## Important information concerning forestay fitting 517-914 (2004 – 2008)

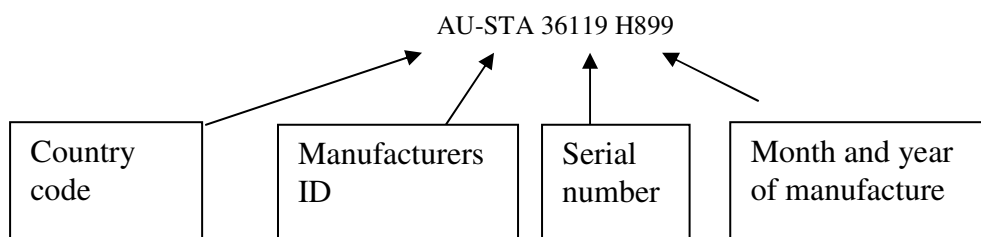
It has been brought to our attention that a few forestay fittings of this design have failed due to a crack in the welding. The crack develops along the weld on the rear side of the fitting inside the mast. It is not visible from the outside. The suspect production batches were used during the period 2004-2008.

All the failed fittings origin from long distance cruising boats with inadequate rig tune and long periods of sailing using only the genoa.

2. If that is the case, please fill out and send the [digital form](#) for contacting Seldén.
3. Seldén will immediately deliver a replacement fitting, art no 517-914-90 and decide when and where the replacement will be carried through – naturally in agreement with the owner of the boat.
